### ADDENDUM NO. 1

PROJECT: Somers Beach State Park Host Pads

FWP PROJECT #: 7216806 DATE: 11-20-2023

## Re: Somers Host Pads Project at Somers State Park for Montana FWP Addendum #1 Summary

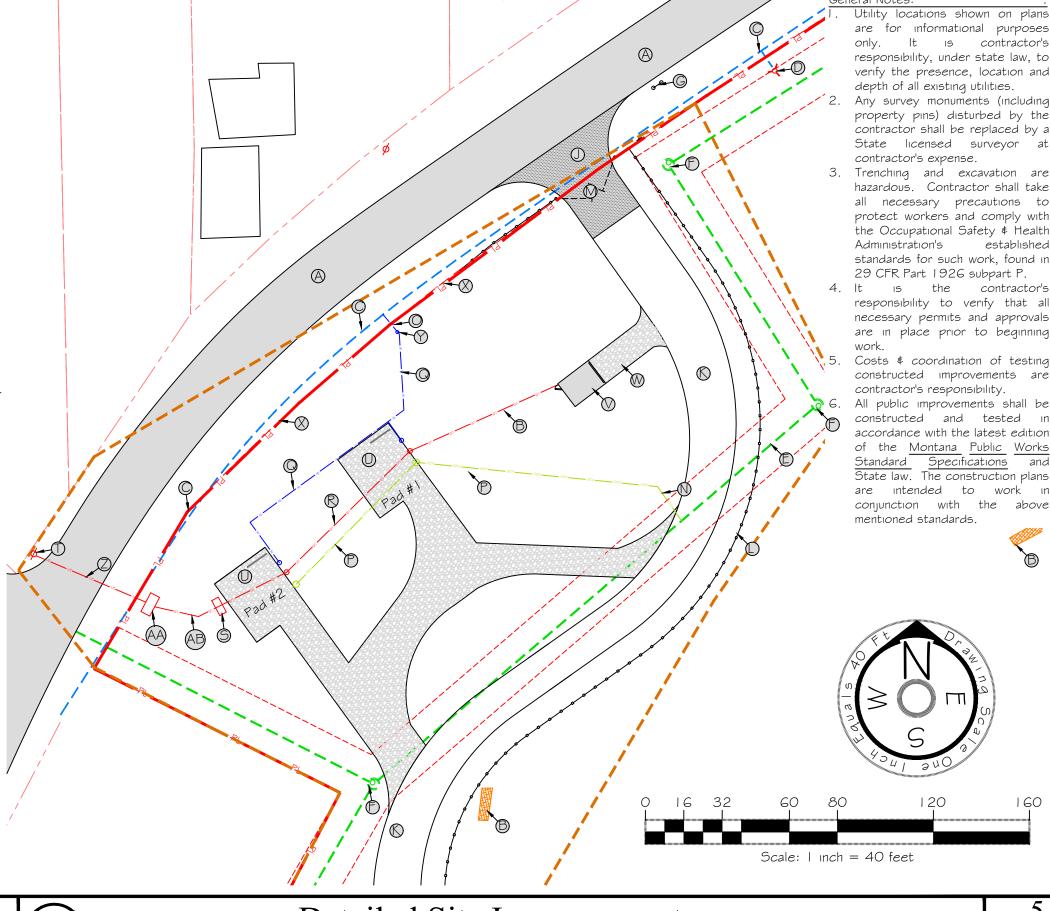
- Page 4 had a numbering error on the "Key Notes for Site Plan". This has been corrected.
- Applicable plan sheets have been revised to reflect clarifications to the electrical plans and details. See attached explanation memo by A2Z engineering dated November 17, 2023.

The plans have been revised to account for some additional information provided by FEC for the power service requirements. FEC revised the pole that the service would connect to and that is reflected on the plans. The design now shows the new underground vault that will be placed on the state park after primary power is brought across the county road and into the park property. The MT FWP will be paying Flathead Electric directly for the cost of the transformer therefore this cost is not the contractors responsibility. The meter and panels have been relocated at the edge of the host site for better proximity to the transformer.

The keyed notes index on sheet 4 was also incorrect, this has been revised as well.

- Existing Water Meter, field verify location
- Z. Proposed 3" Conduit from pole to underground vault with conductors per FEC
- AA. Underground Concrete Vault for Proposed Transformer (Transformer Provided by FEC and paid for directly by MT FWP)

- AB. 3" Conduit from Vault to Meter Location

MONTANA FISH, Detailed Site Improvements
WILDLIFE & PARKS Somer's Beach State Park - Phase 2 Host Pads Project

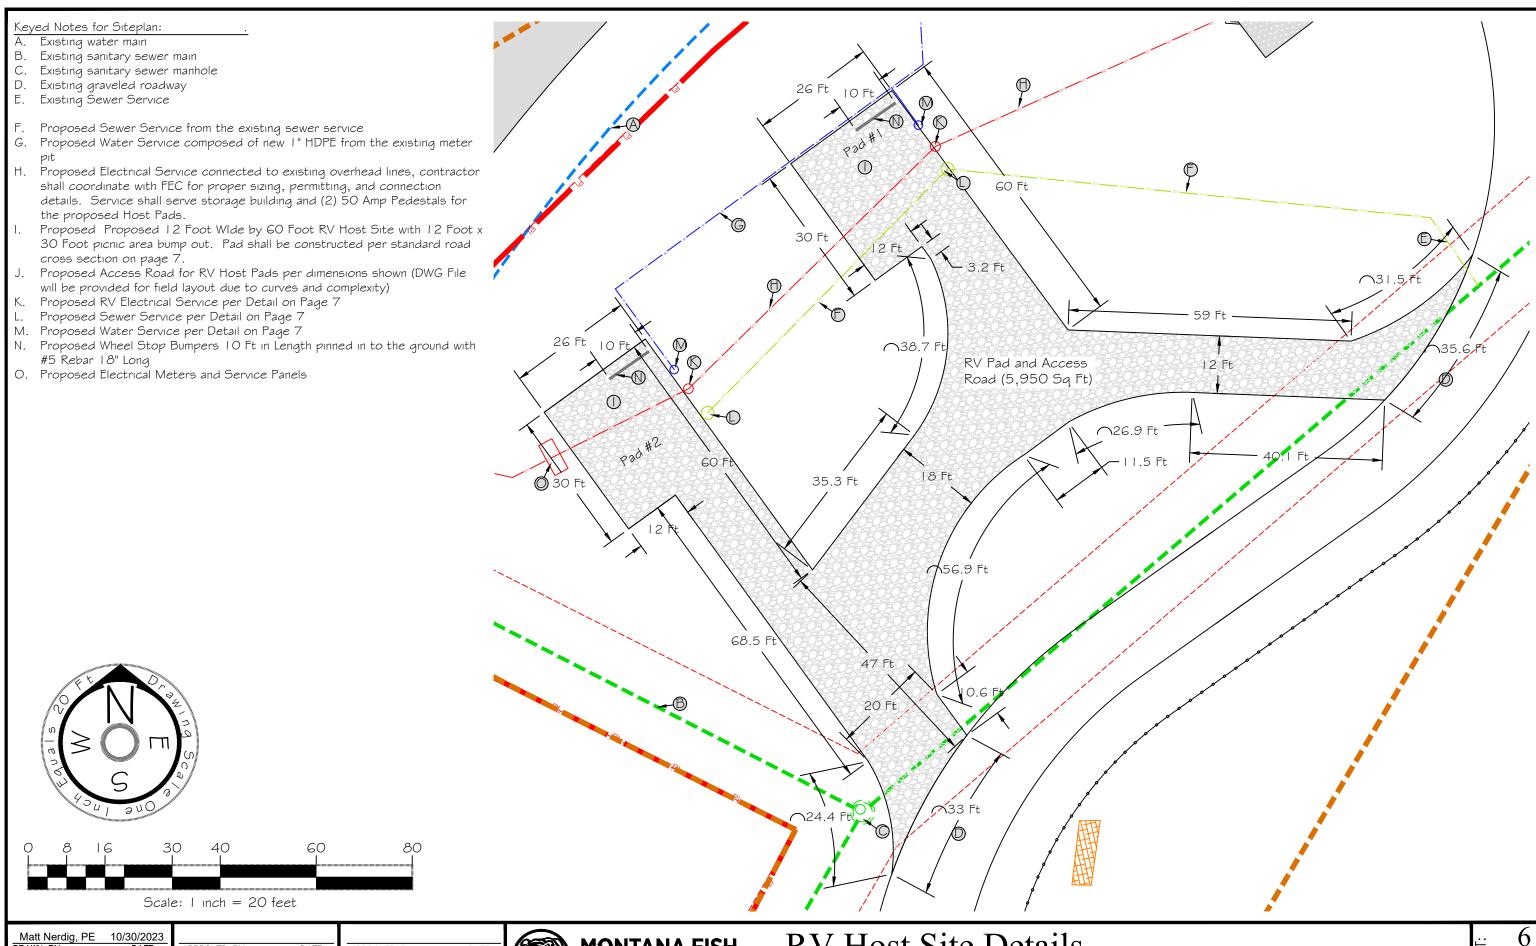
Plan Sheet 5 of 7: Maintenance Shed clarification: colors for the maintenance shed can be factory applied. The delta rib metal roofing will generally be a chocolate brown color and the siding a tan color.
